City of Portland, Oregon
Bureau of Development Services
Land Use Services
FROM CONCEPT TO CONSTRUCTION

NOTICE OF A TYPE II DECISION ON A PROPOSAL IN YOUR NEIGHBORHOOD

CASE FILE NUMBER: LU 14-198444 DZ ***NEW MIXED-USE BUILDING IN KENTON***

2.1 COURTYARD EAST ELEVATION
WEST
1/8" = 1'-0"

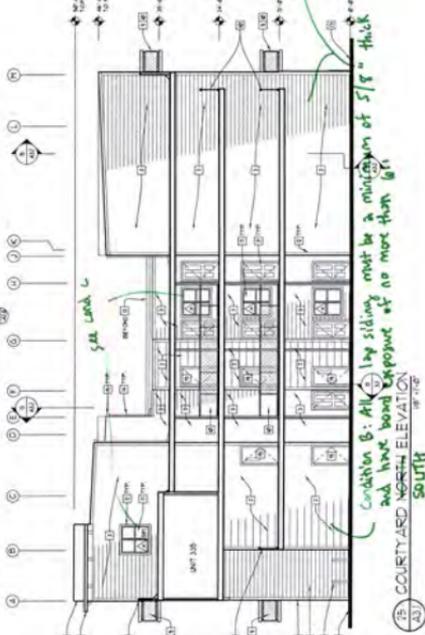
The elevations show small slider-type windows on one of the courtyard façades (Courtyard East Elevation). The addition of this window typology is an unnecessary convolution of the building. The sliding window is not a typology used on historic buildings in the area. A condition of approval will ensure no sliding windows are used on the project. These windows can become either fixed, casement or single/double-hung windows to align these windows better with the rest of the building and the neighborhood and adjacent historic and conservation districts.

Condition C: All vinyl windows and doors must be replaced at least 30%.

- C. All vinyl windows and all doors (excepting those in the storefront system) must be recessed into the building so that the distance between the outside of the trim and either the window glass or door is a minimum of 3 inches.

- E. No windows on the building can be the slider or sliding type window. Fixed, casement or single or double-hung windows are acceptable replacements.
